Addendum 02
2022 Bond
Painting Project Districtwide
Package A
Package B

Pasadena ISD
CSP#26P-040LP

22 May 2026

This addendum modifies the original Bid Proposal Documents dated April 29, 2026 and forms a part of the Contract Documents.

Sheet
A4

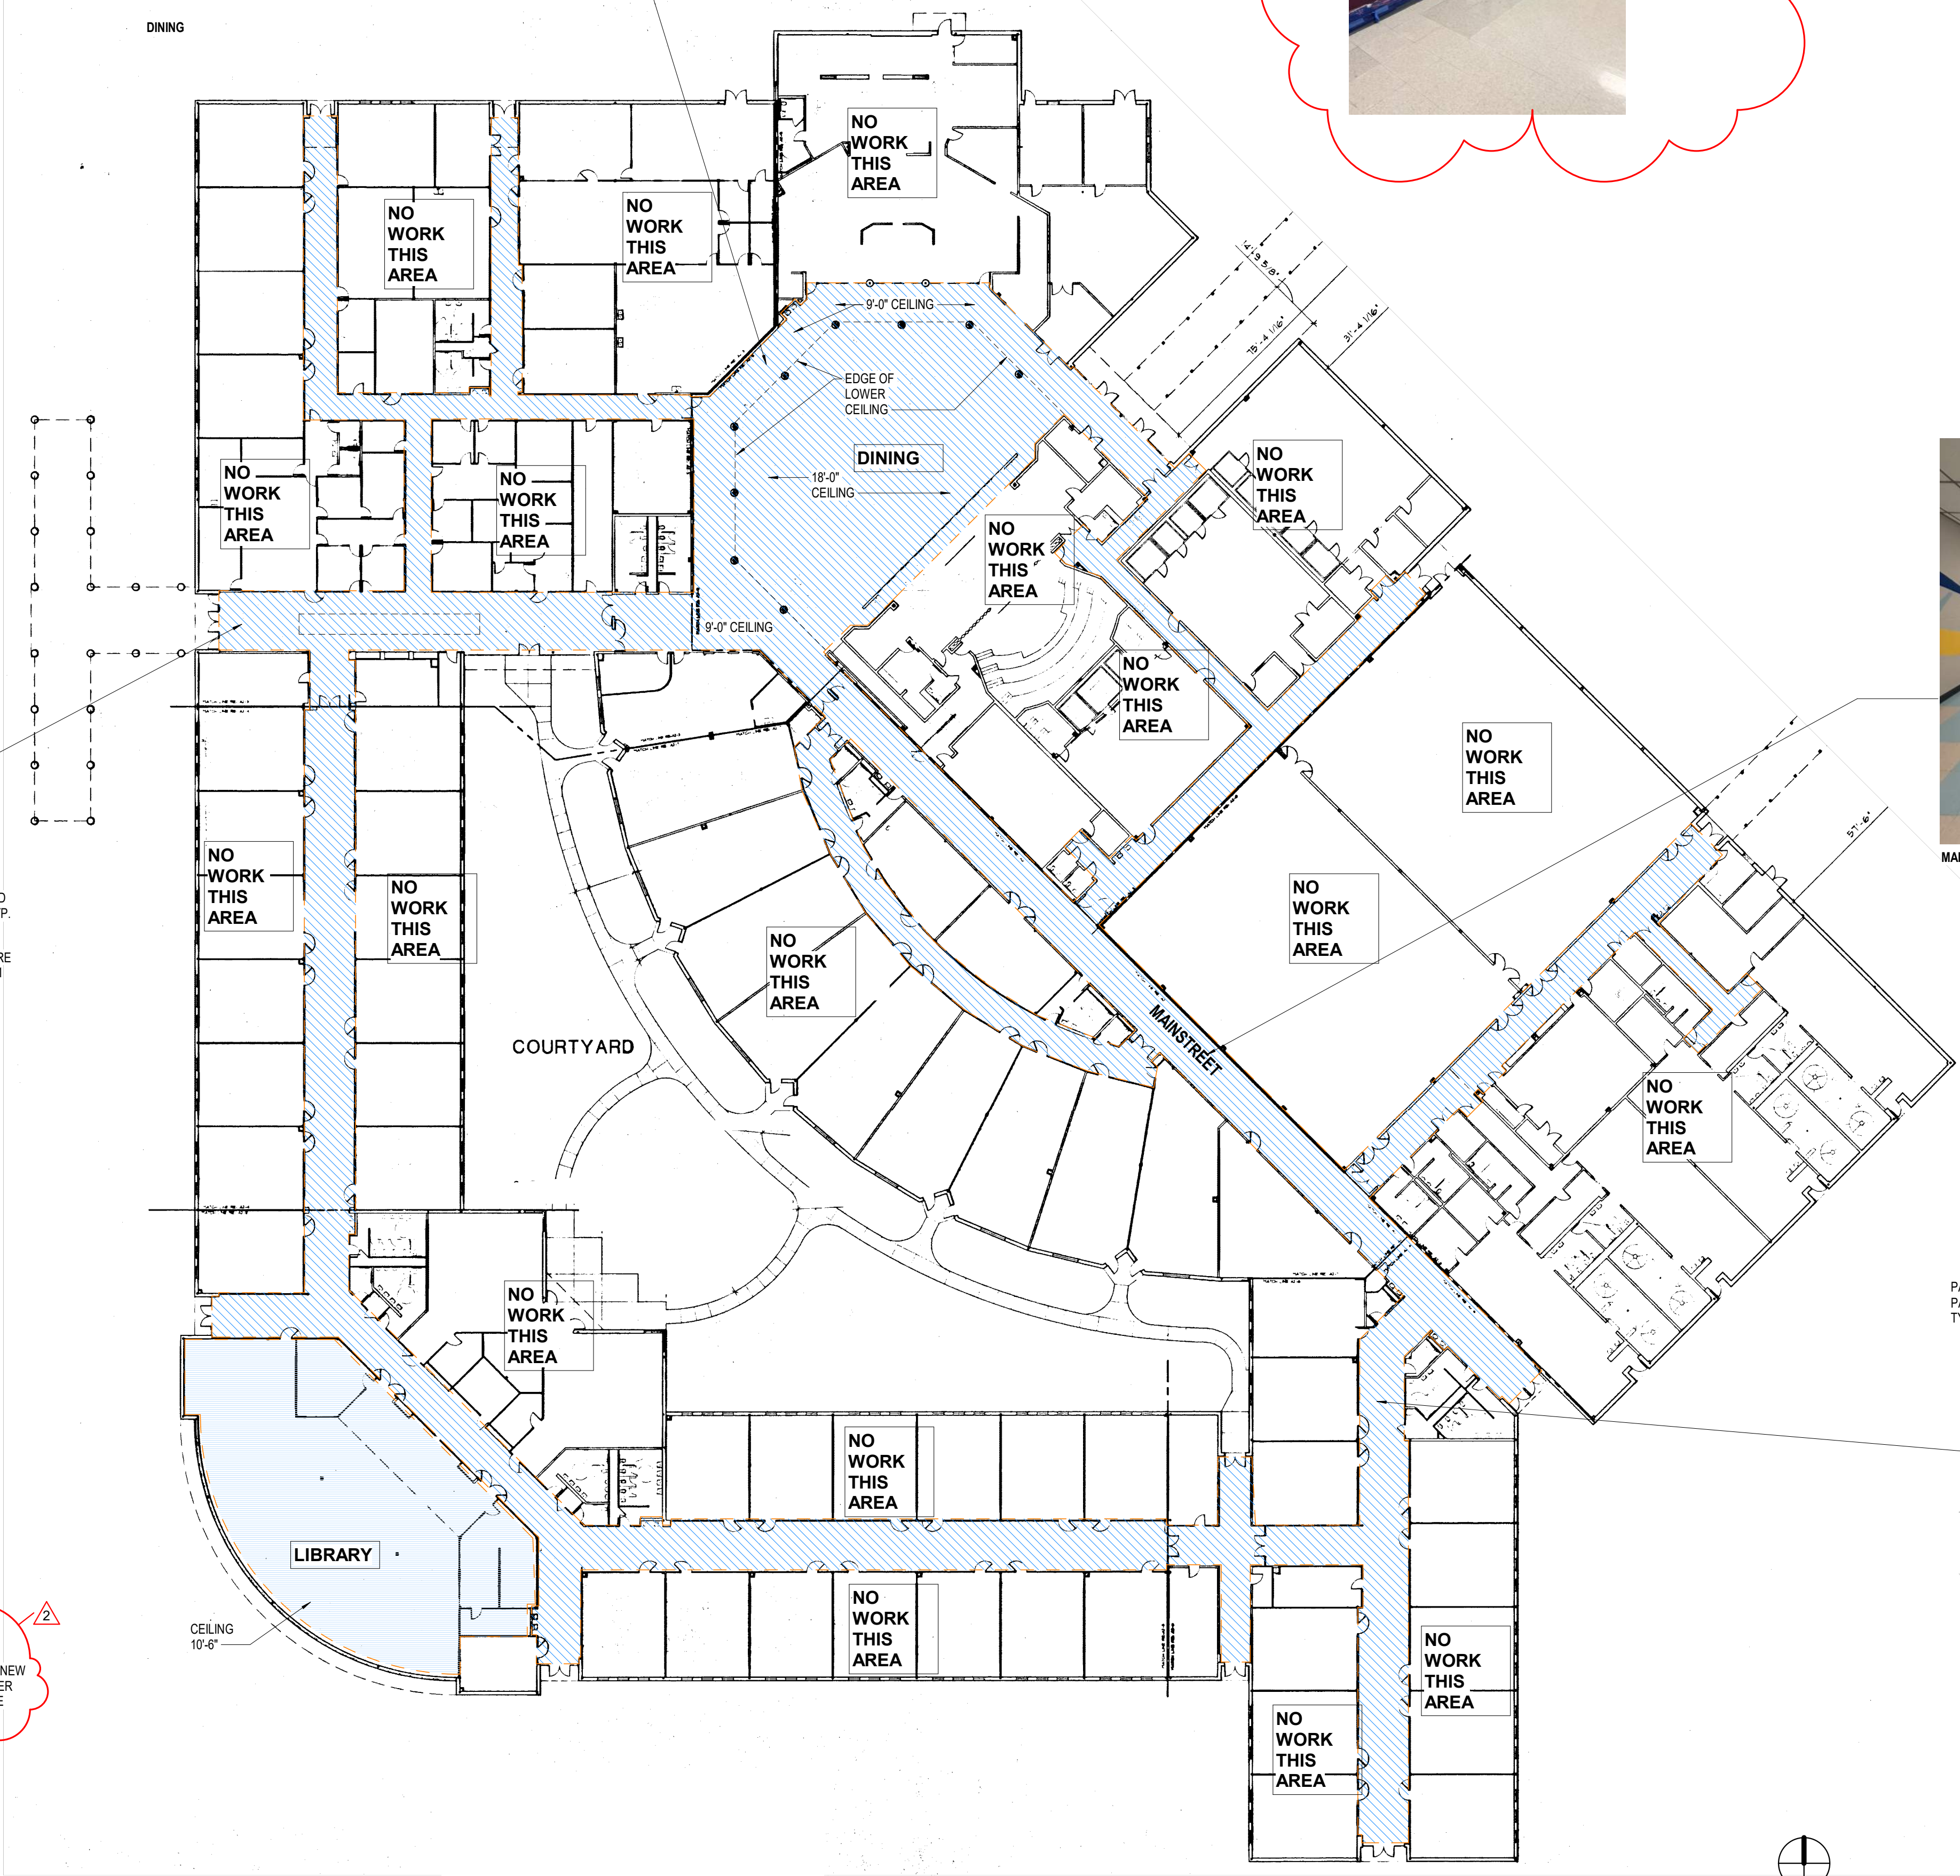
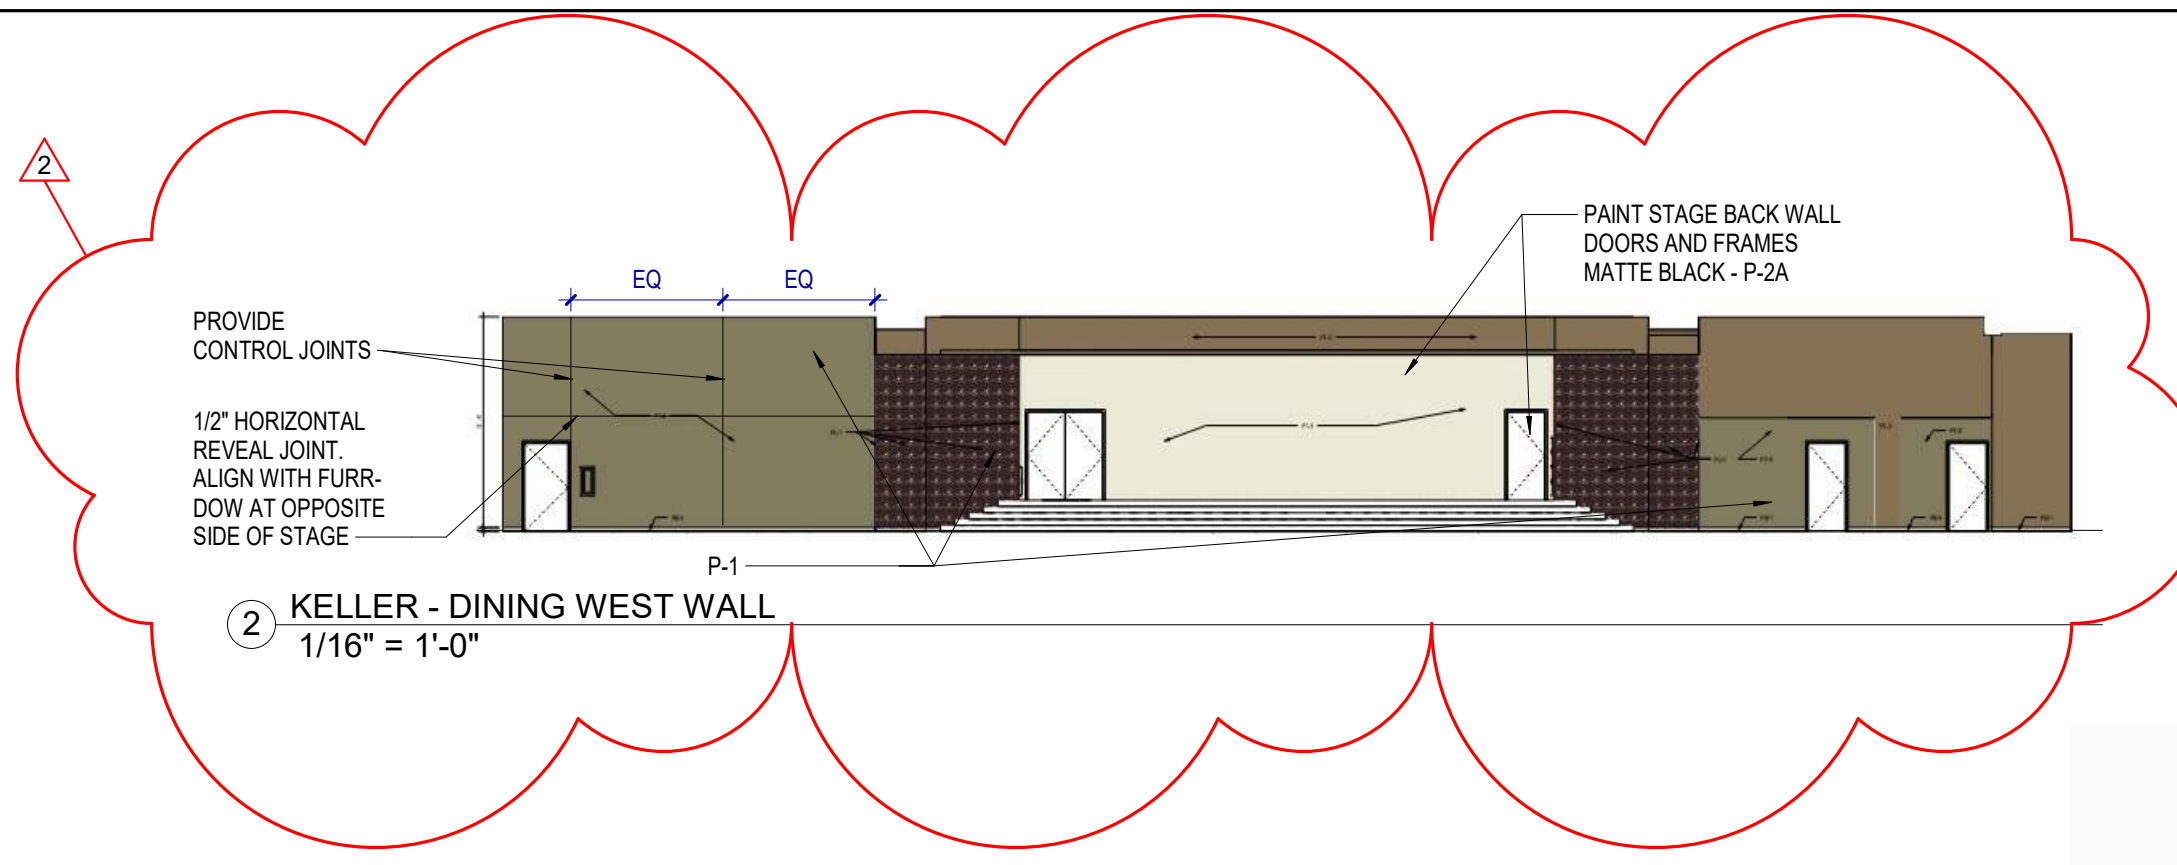
- 01 A1 – Sullivan Middle School: Replace with Revised Sheet A1.
 - a. Paint Classroom Walls, Hollow metal door and window frames in Classrooms
- 02 A2 – The Summit Replace with Revised Sheet A2.
 - a. Remove existing base in Gymnasium and provide new base to match existing.
 - b. Paint Hollow Metal Door and Window frames on both sides, Typical.
- 03 A3 – De Zavala Middle School Replace Revise Sheet A3.
 - a. Remove vinyl wall covering in classrom wall, Paint P-1.
 - b. Paint Gymnaisum walls and steel structure to existing Metal Wall Panel height.
 - c. Paint Dining room cmu walls and steel structure to existing Metal Wall Panel height. Paint background of existing wall graphics. Existing wall graphics to remain.
 - d. Replace Revise sheet A3.
- 04 A4 – Jackson Intermediate School: Replace with Revised Sheet A4

- a. Provide corner guards at outside corners of corridor walls.
- b. Repaint Existing Graphics in Athletic Corridor.
- c. Paint over vaulted ceiling in entrance corridor.

Sheet
B2

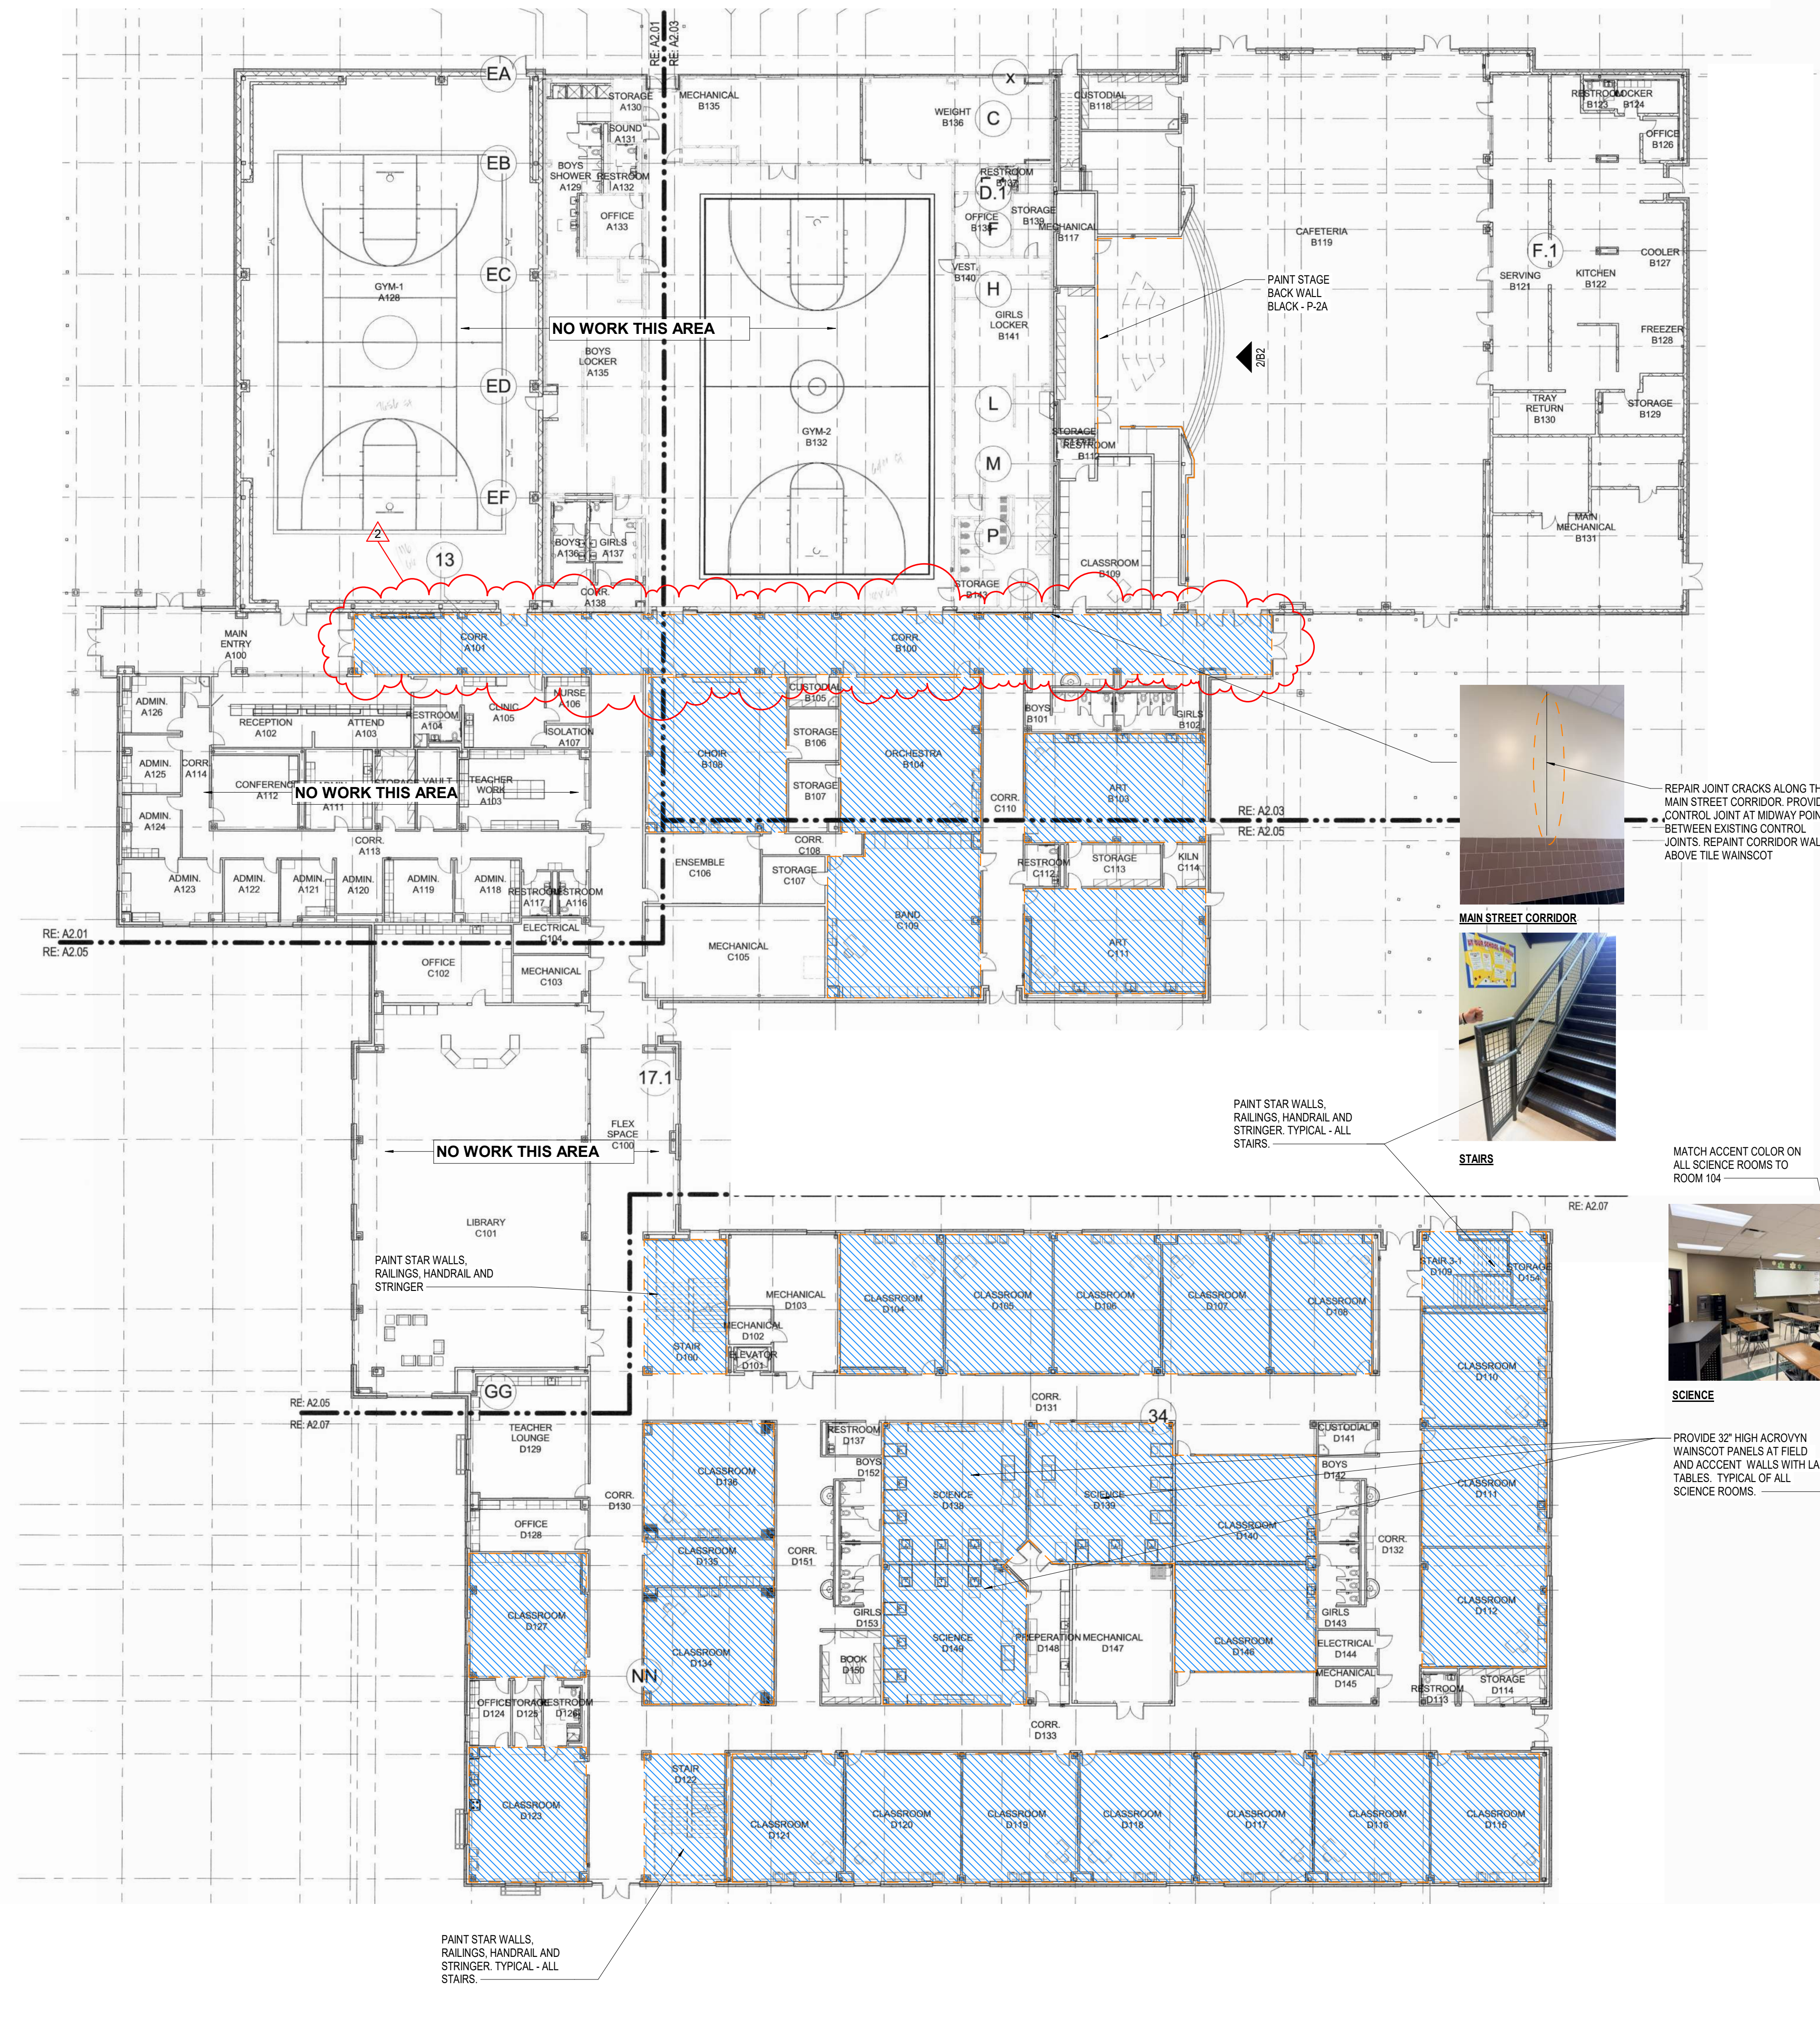
06 B2 – Keller Middle School, Revise as follows:

- a. Paint Entrance Corridor.
- b. Paint west wall of cafeteria.
